HISTORIC AND DESIGN REVIEW COMMISSION

HDRC CASE NO: 2022-505
ADDRESS: 515 CLUB DR
LEGAL DESCRIPTION: NCB 7070 (R MATAMOROS SUB), BLOCK 9 LOT 25
ZONING: RM-4, H
CITY COUNCIL DIST.: 7
DISTRICT: Monticello Park Historic District
APPLICANT: Gilbert Garza/Garza Design-Build LLC
OWNER: Celeste Leija
TYPE OF WORK: New construction of a 1-story, single-family residence
APPLICATION RECEIVED: September 16, 2022
60-DAY REVIEW: Not applicable due to City Council Emergency Orders
CASE MANAGER: Rachel Rettaliata

The applicant is requesting conceptual approval to construct an approximately 2,400-square-foot 1-story, single-family residential structure.

FRONT ELEVATION
Scale: 1/4" = 1'-0"

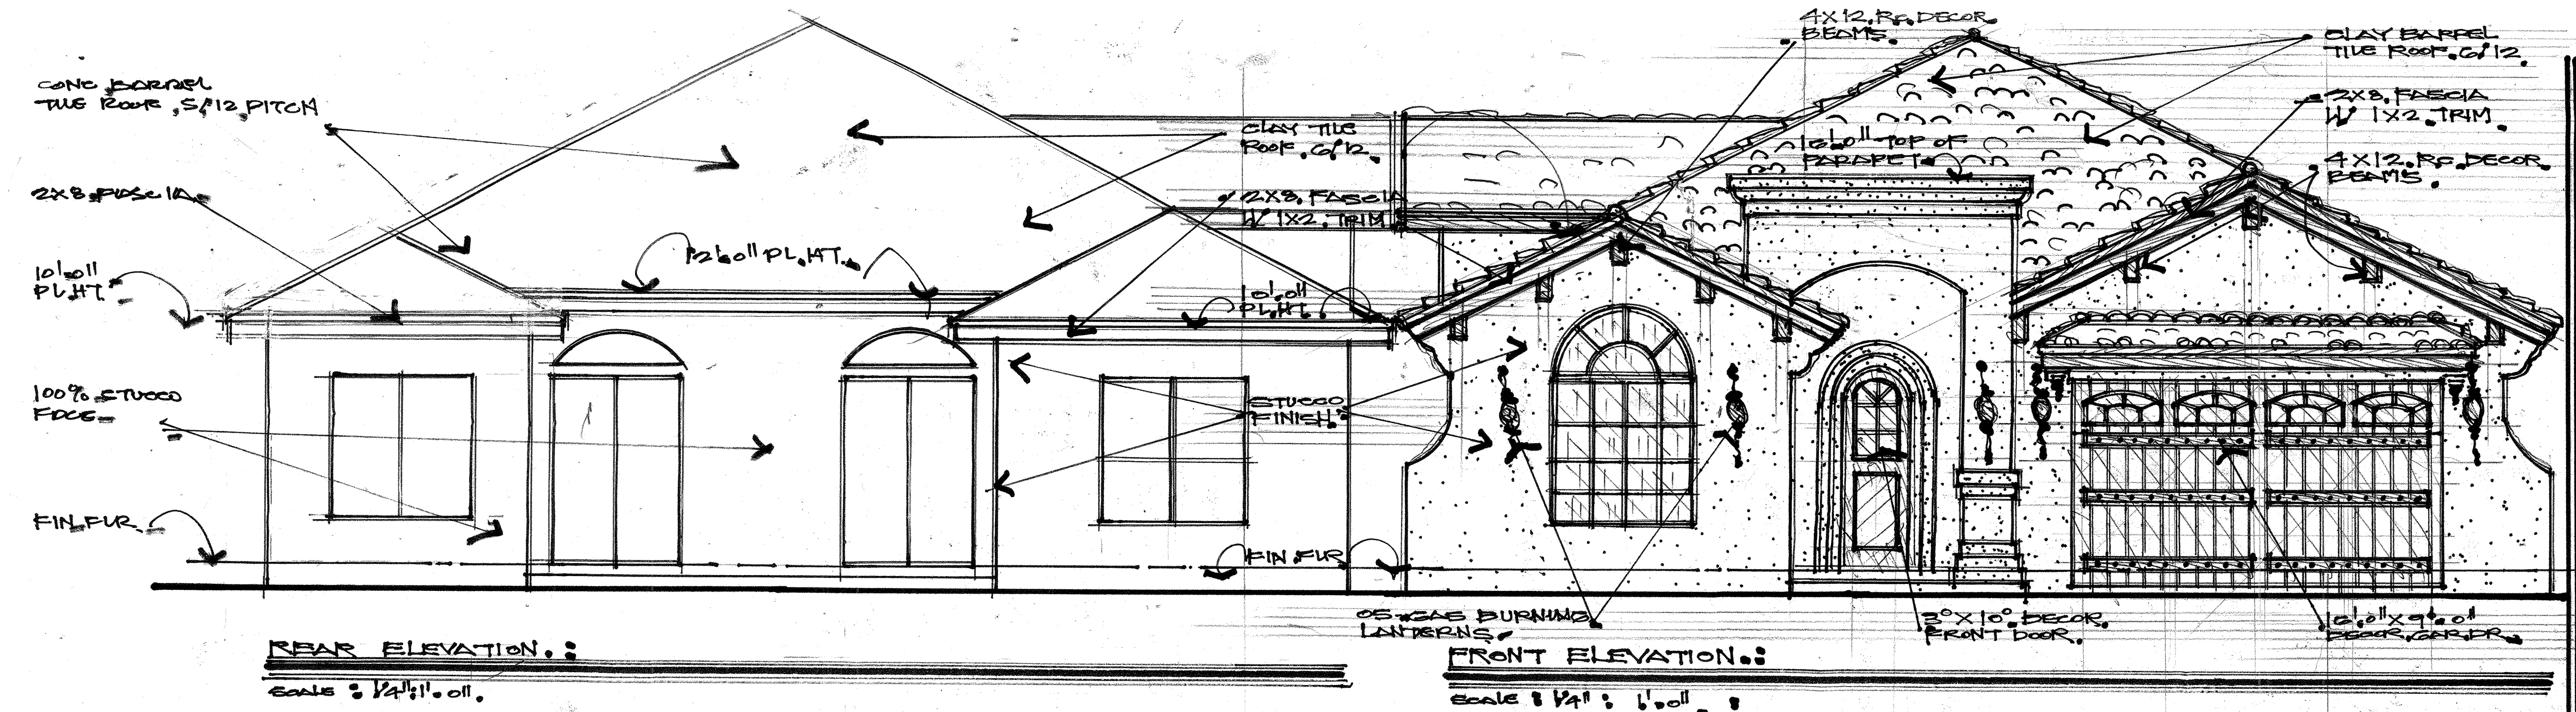
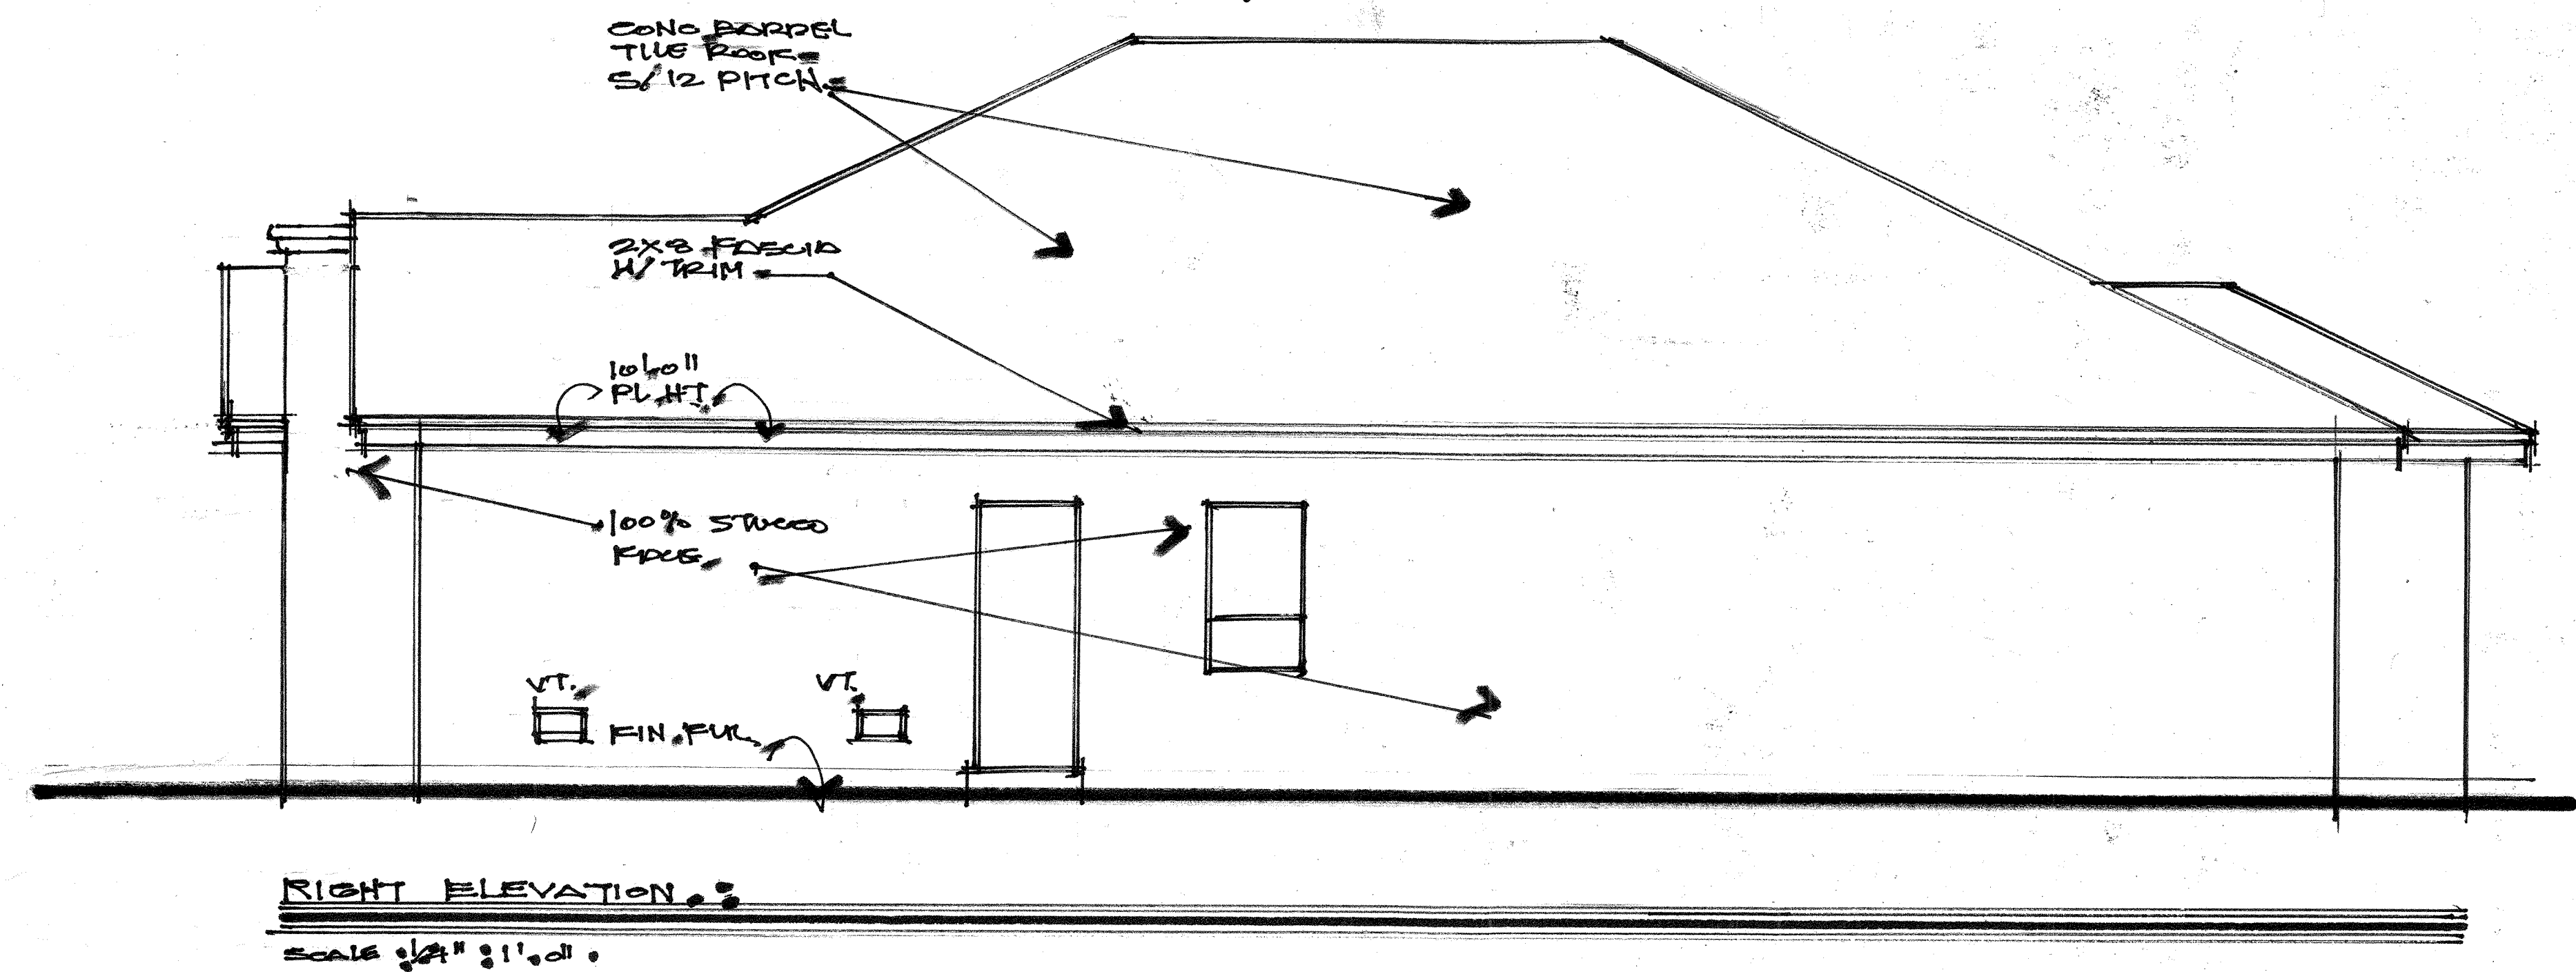
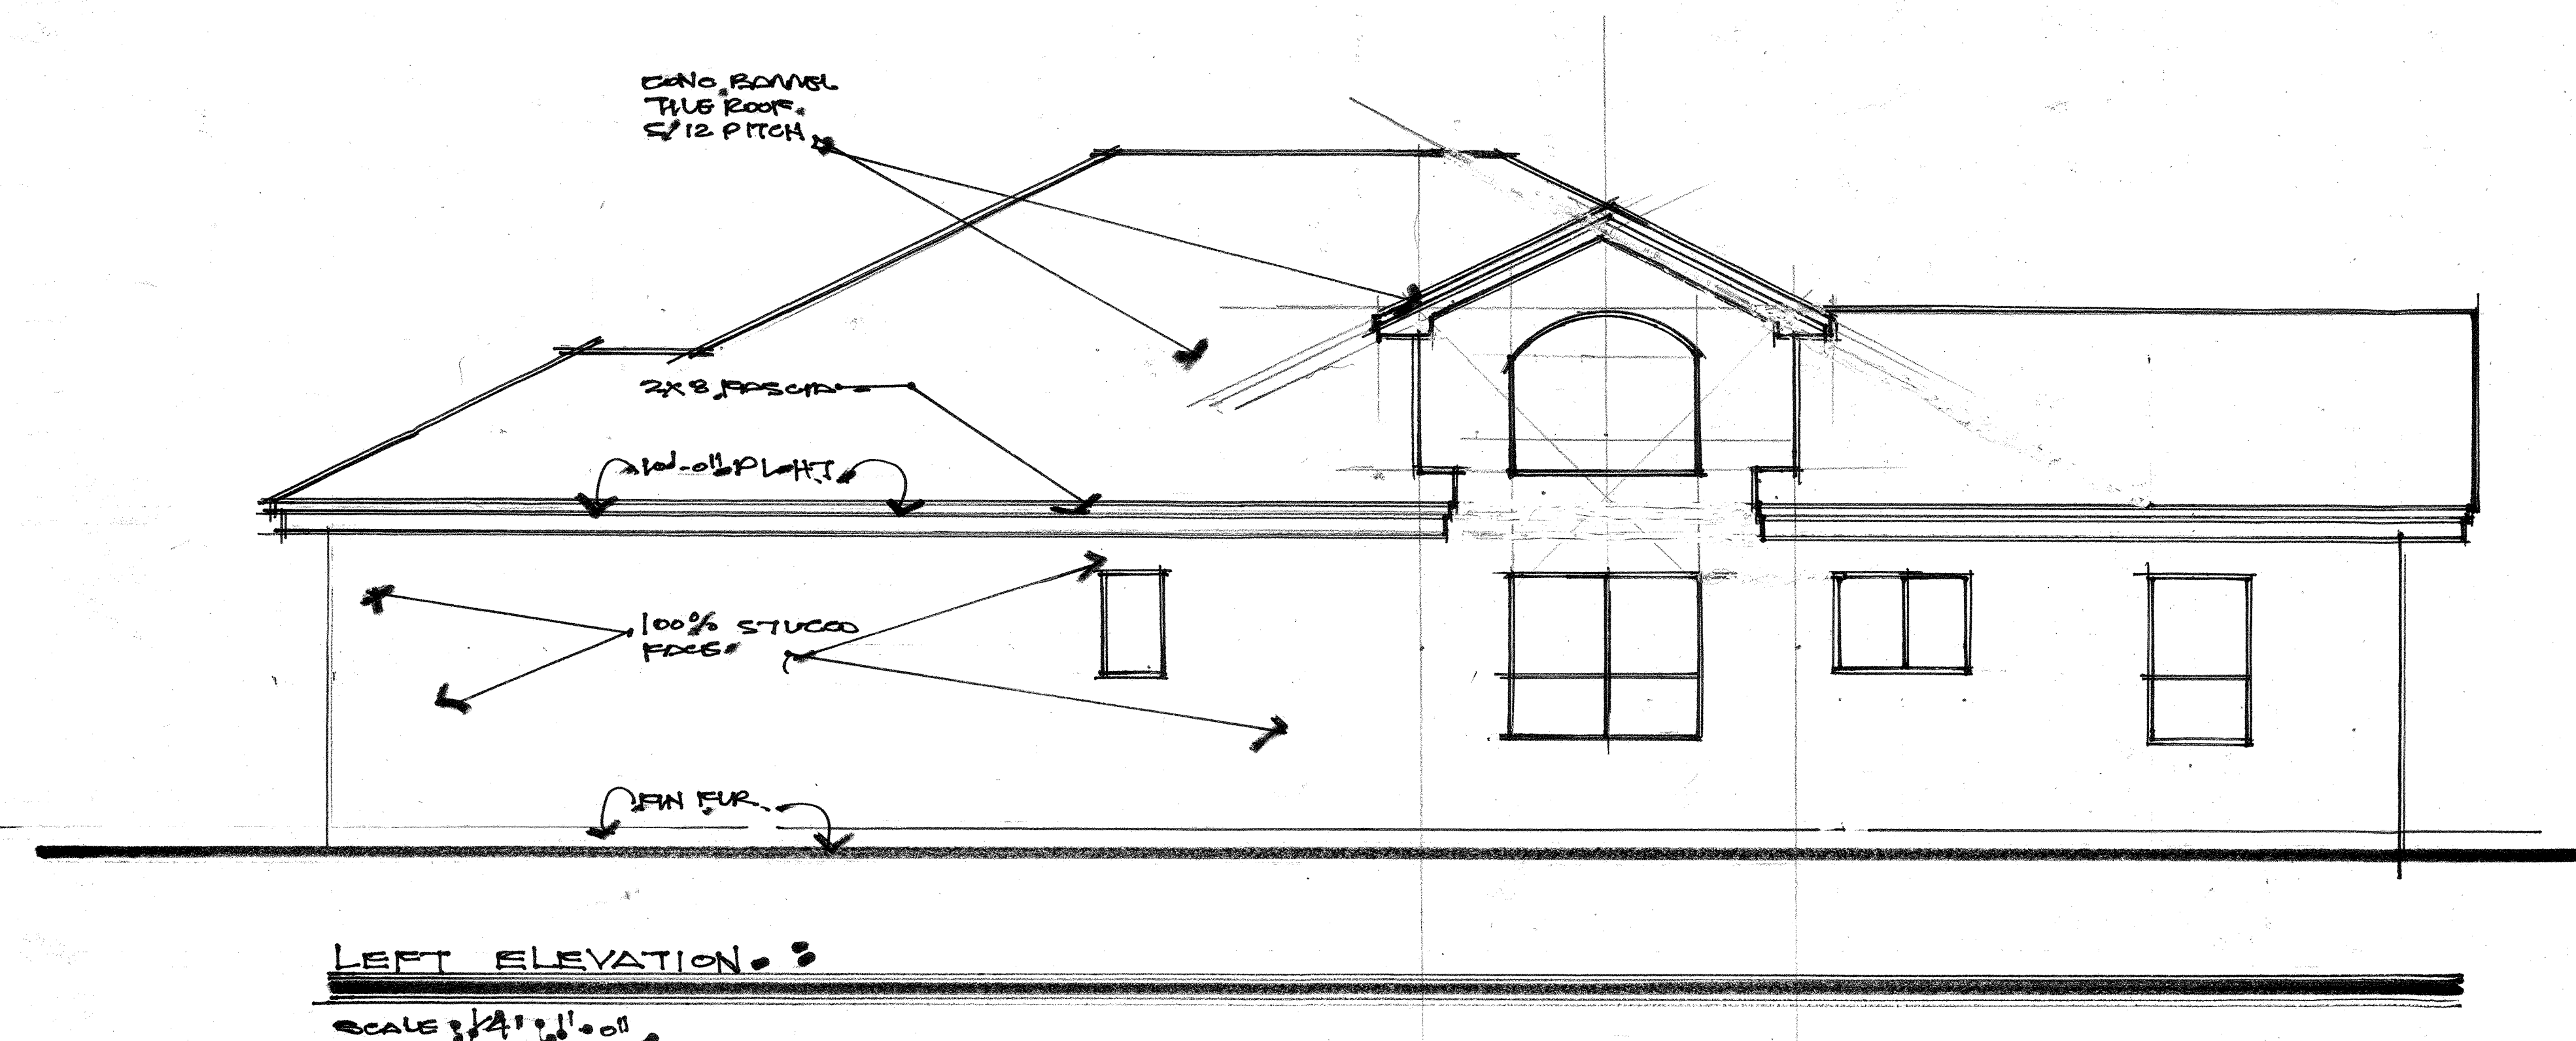
- j. **RELATIONSHIP OF SOLIDS TO VOIDS** – Guideline 2.C.i for New Construction stipulates that new construction should incorporate window and door openings with a similar proportion of wall to window space as typical with nearby historic facades. Windows, doors, porches, entryways, dormers, bays, and pediments shall be considered similar if they are no larger than 25% in size and vary no more than 10% in height to width ratio from adjacent historic facades. The applicant has proposed a fenestration pattern on the front façade that features an arched entry, one large arched window, and a garage door with arched transom lites. The fenestration pattern on the remaining elevation consists of an arched window, arched transoms over French doors, and divided lite and fixed windows of various sizes. The proposed east elevation features a blank wall at the rear half of the elevation. According to Guideline 2.C.ii, no new façade should exceed 40 linear feet without being penetrated by windows, entryways, or other defined bays. Staff finds that the applicant should update the proposed fenestration to feature traditional proportions and window configurations commonly found in the district.

- k. **ARCHITECTURAL DETAILS** – Guideline 4.A.i for New Construction states that new buildings should be designed to reflect their time while respecting the historic context. While new construction should not attempt to mirror or replicate historic features, new structures should not be so dissimilar as to distract from or diminish the historic interpretation of the district. Additionally, Guideline 4.A.ii for New Construction states that applicants should incorporate architectural details that are in keeping with the predominant architectural style along the block face or within the district when one exists. Details should be simple in design and should complement, but not visually compete with, the character of the adjacent historic structures or other historic structures within the district. Architectural details that are more ornate or elaborate than those found within the district are inappropriate. The applicant has proposed to install decorative gas lanterns flanking the front arched window, the front entry, and the garage, and a recessed arched entry. Staff finds the architectural details to be in keeping with the Guidelines.
